SUBJECT: RECALL R09PX INCORRECT SPARE TIRE LOADING DATA

FMVSS 110 Noncompliance Incorrect Spare Tire Pressure Data

RECALL

Models Affected: Certain 2010 Model Year Micro Bird Single Rear Wheel Model Buses
Manufactured from August 31, 2005 through September 27, 2009

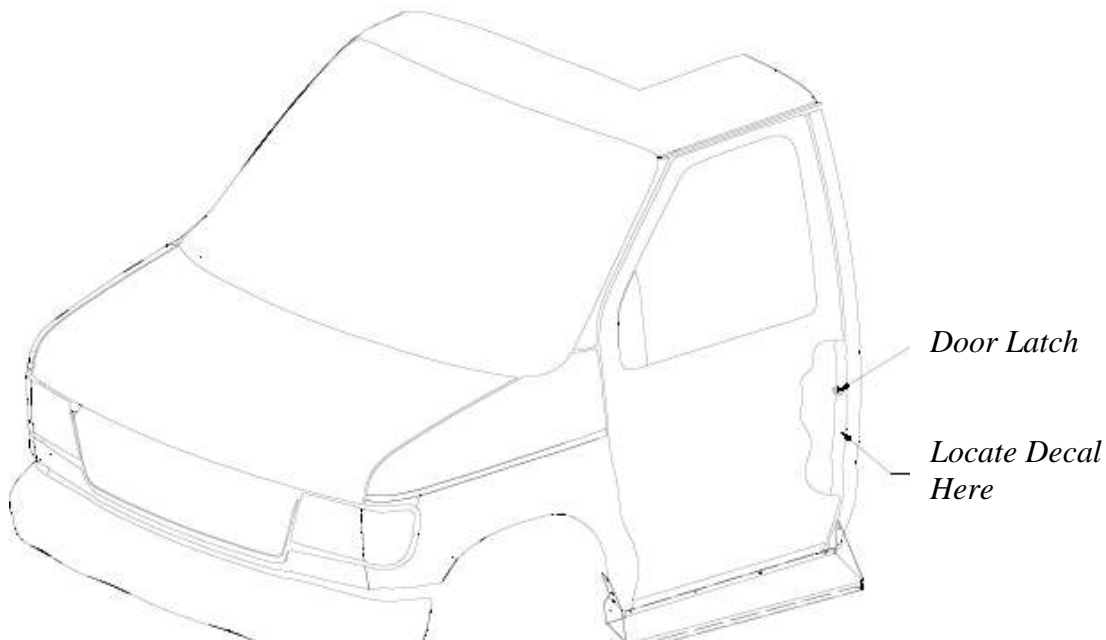
The placard, as originally installed, listed inflation pressure for a spare tire that was the same as the front tire inflation pressure. Inflation pressure required for the rear tire could be higher than the front tire. A failure occurring in tires due to inappropriate spare tire pressure could result in loss of control of the vehicle and vehicle crash.

The tire and loading placard may not be in compliance with FMVSS 110 S4.3.4c regarding spare tire pressure information.

A replacement decal indicating appropriate spare tire pressure as required by FMVSS 110 S4.3.4c will be provided to owners to install.

1. Park the vehicle on a level surface, apply parking brake, turn engine off, remove ignition key.
2. Open driver's door and locate tire pressure label as shown below.
3. Clean existing decal with damp cloth or paper towel and dry thoroughly.
4. Carefully place new tire pressure label on top of existing decal.
5. Return bus to service.
